PRELIMINARY/FINAL DRAINAGE REPORT

APPALOOSA HWY 24 SUBDIVISION FILING NO. 1A, LOTS 1, 2 & 3

**ADP Project No. 160504
September 19, 2018**

DETENTION BASIN STAGE-STORAGE TABLE BUILDER

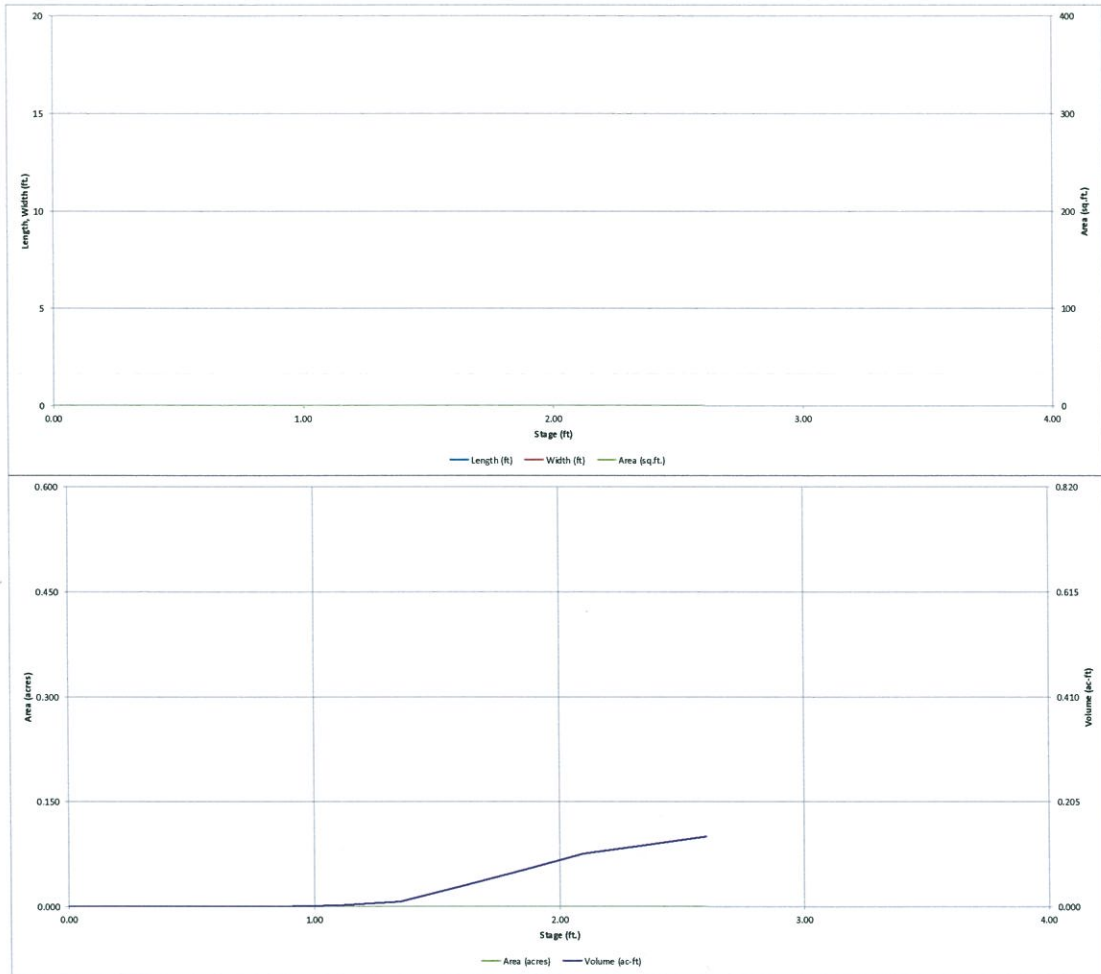
Input the optional override date for the stage and area so that the design volume will meet the minimum requirements.

Detention Basin Outlet Structure Design

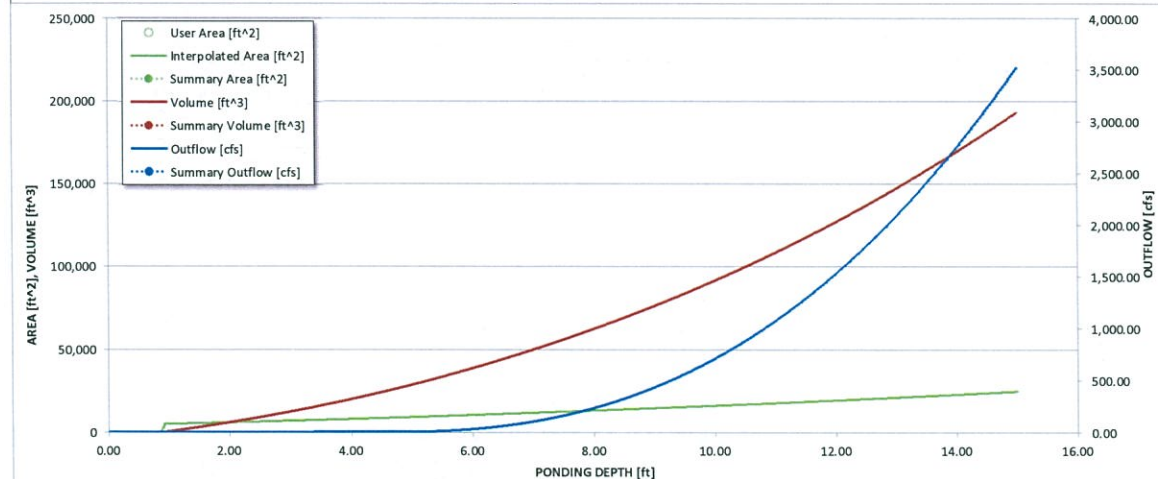
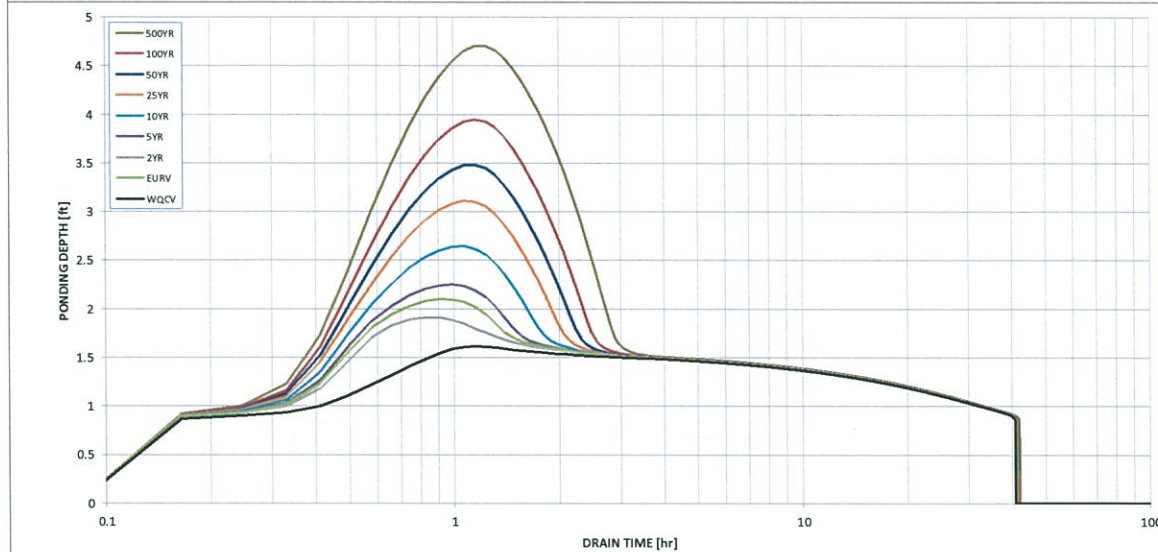
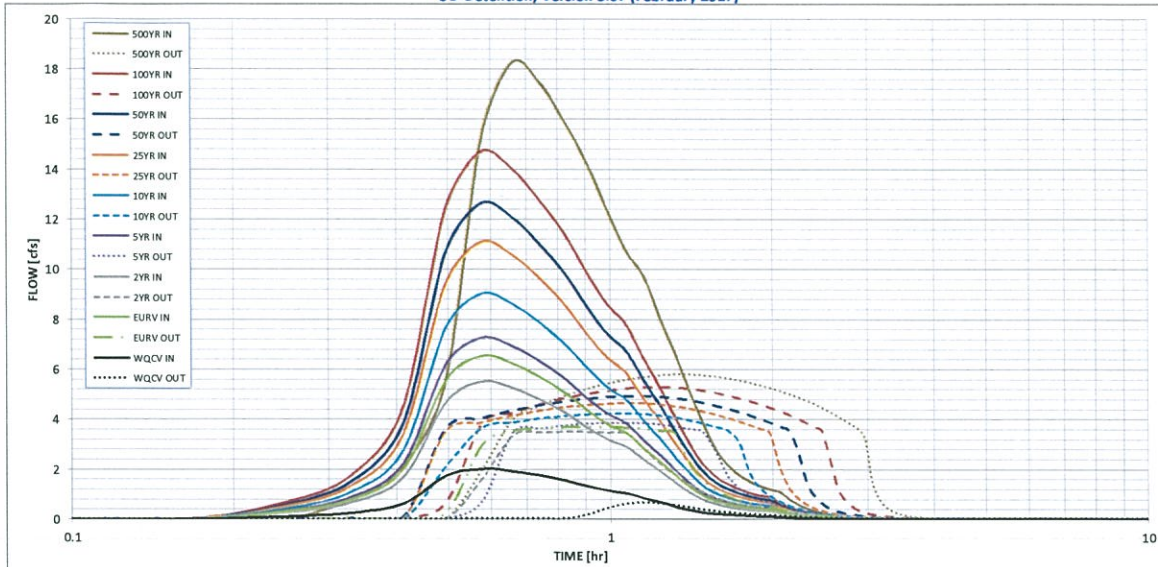
Must release at or below the predeveloped rate. Revise.

Revise these values to match the design in the GEC Plan or vice versa.

APPALOOSA HIGHWAY 24 SUBDIVISION
FILING NO. 1A
COLORADO SPRINGS, COLORADO
EXISTING DRAINAGE PLAN

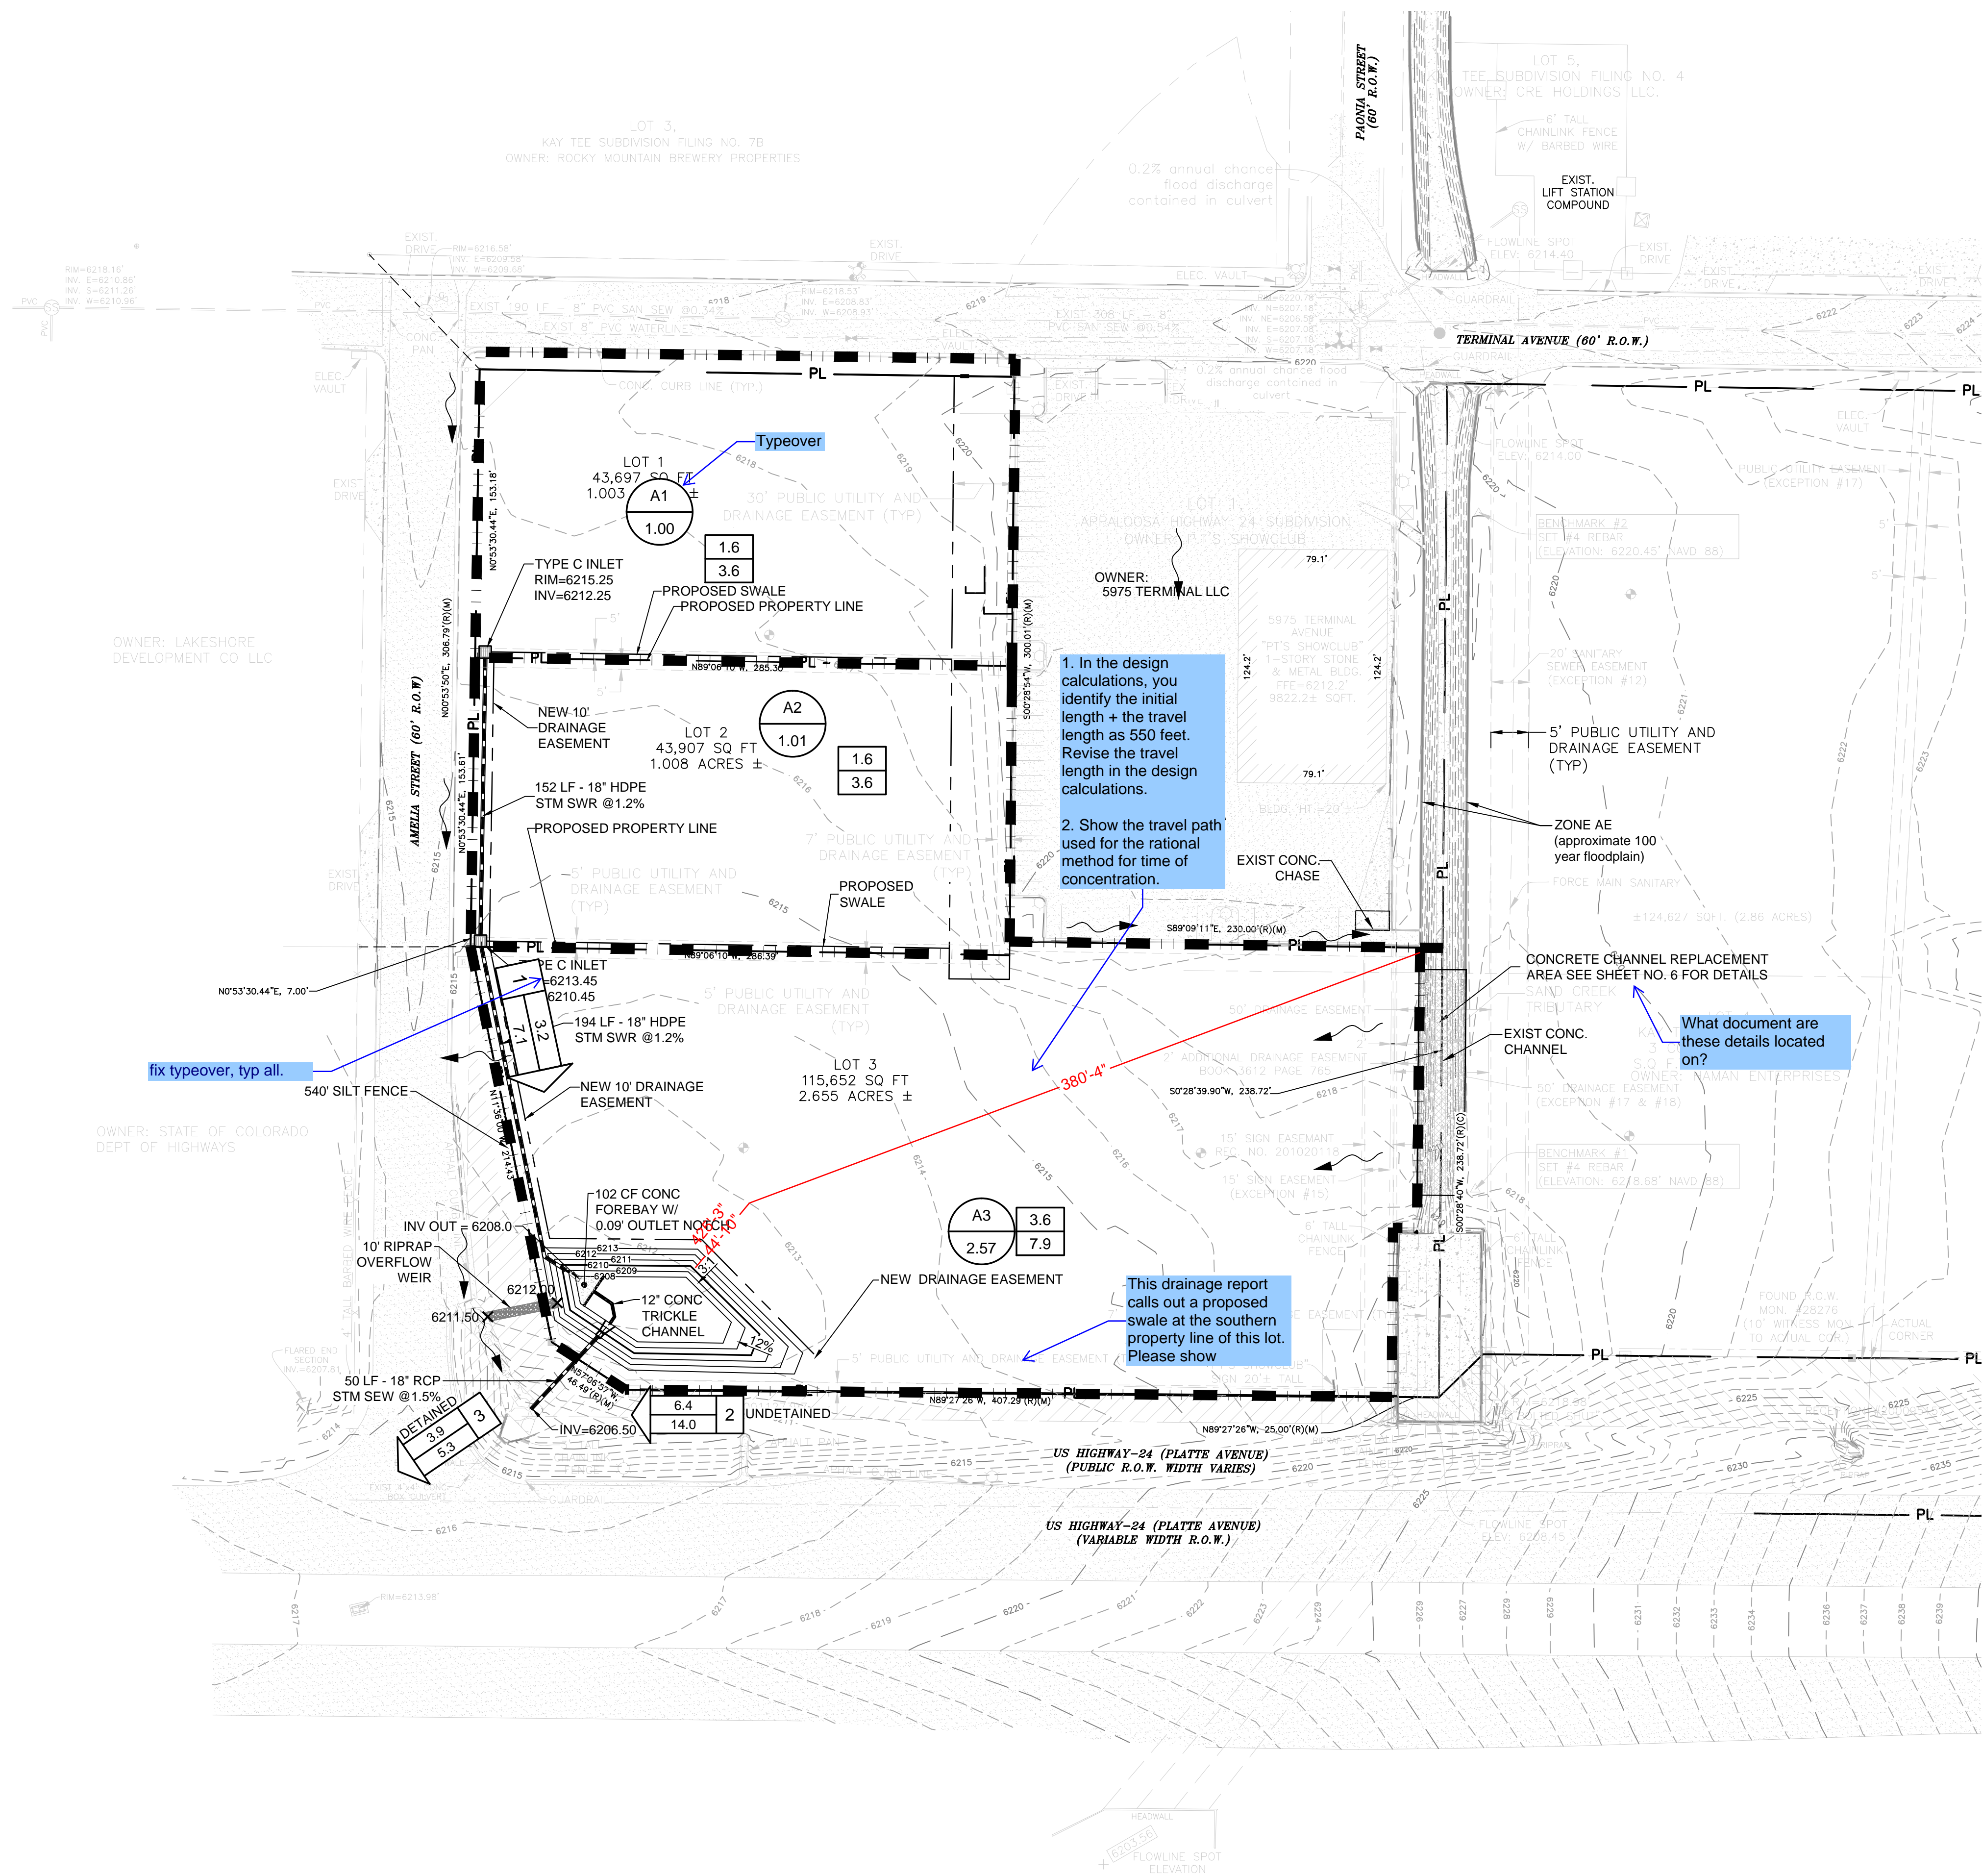
These values do not match what is shown in the existing drainage map. Please confirm which is correct.

These values do not match what is shown in the existing drainage map. Please confirm which is correct.

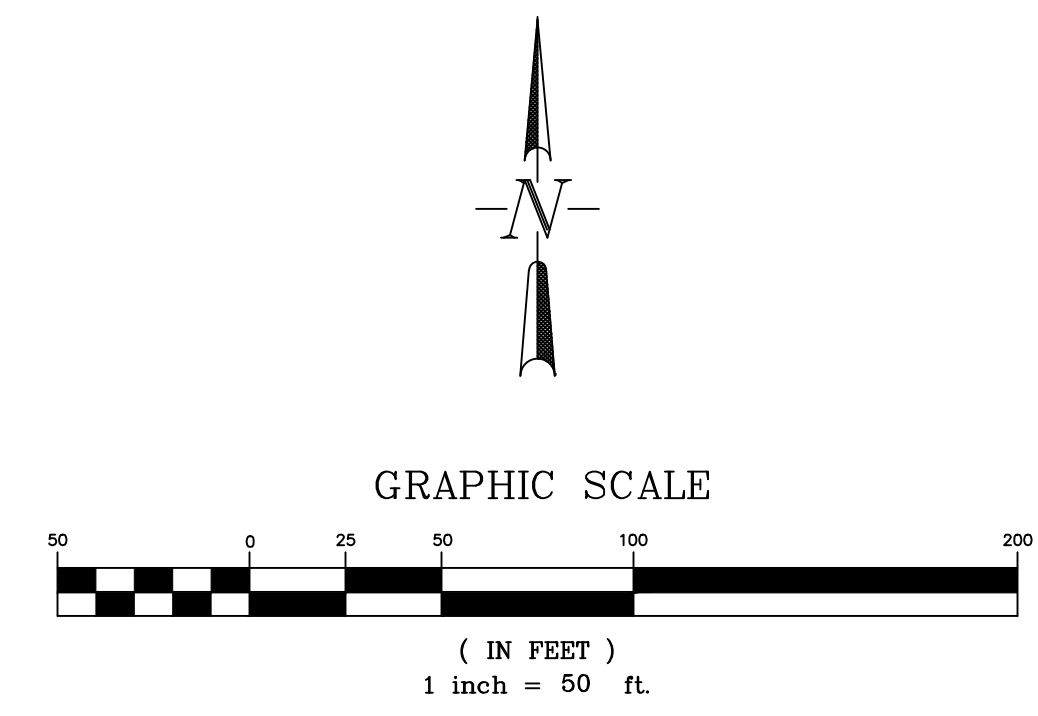
Please clearly show property boundaries.
Please make ownership labels for adjacent parcels readable, as well as other items shaded back.
Please call out who currently owns and maintains this channel.

This drainage report calls out a proposed swale at the southern property line of this lot. Please show

Please clearly show property boundaries. Please make ownership labels for adjacent parcels readable, as well as other items shaded back. Please call out who currently owns and maintains this channel.

Add a design point here and add verbiage to the text stating that the proposed flow does not exceed the existing.

Maximum length of overland flow for urban areas is 100 feet.

1. In the design calculations, you identify the initial length + the travel length as 550 feet. Revise the travel length in the design calculations.

2. Show the travel path used for the rational method for time of concentration.
